**CITY OF MERIDIAN
FINDINGS OF FACT, CONCLUSIONS OF LAW
AND DECISION & ORDER**

In the Matter of the Request for Short Plat to Create Two Buildable Lots on Approximately 0.31 Acres in the R-8 Zoning District, by Matthew Ferguson.

Case No(s). SHP-2022-0007

HEARING DATE: 6/28/2022
TO: Mayor & City Council
FROM: Alan Tiefenbach, Associate Planner
208-498-0573
SUBJECT: SHP-2022-0007
Ferguson Townhomes Short Plat
LOCATION: 1335 NE 4th Street

B. Proposed Short Plat (date: 3/11/2022)

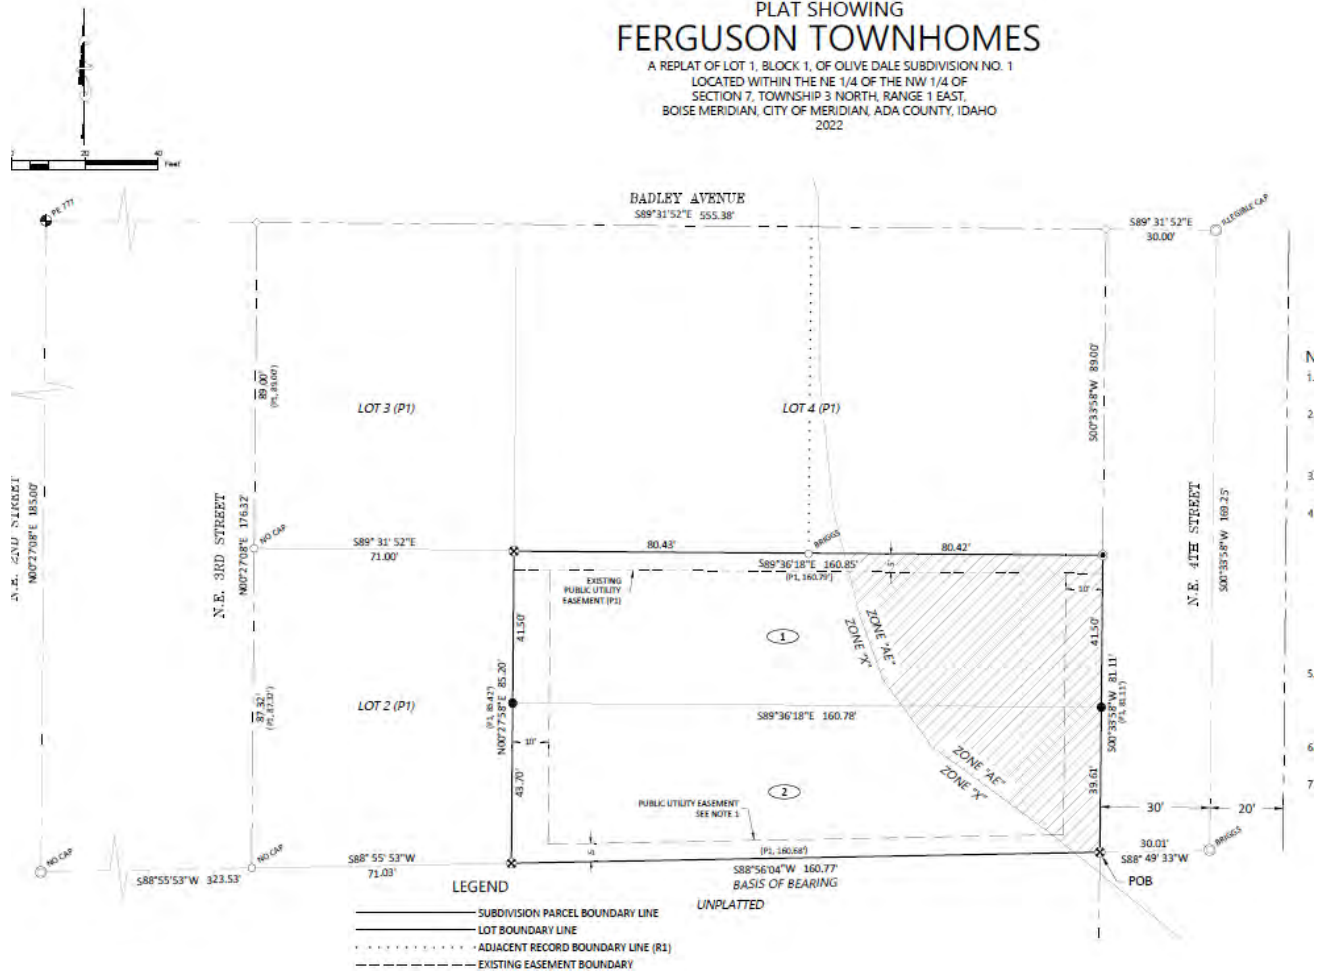
Staff has reviewed the requested short plat proposal. If the plat is revised to adjust the internal lot line between Lots 1 and 2 so both lots meet the minimum 40 ft. frontage requirement in the R-8 zoning district, the proposal would meet the criteria for approval per UDC 11-6B-5.

1. The short plat prepared by Aaron P Rush PLS, dated 3/11/2022, included in Section VI.B is approved with the following revision:
 - a) The applicant shall reconfigure the internal lot between Lots 1 & 2 to meet the minimum 40 ft. lot frontage requirement of the R-8 zoning district.

- b) The internal lot line between Lots 1 & 2 shall be graphically depicted as a zero-lot line.
2. The applicant shall obtain a floodplain permit in conformance with UDC 11-6B-5 prior to building permit.
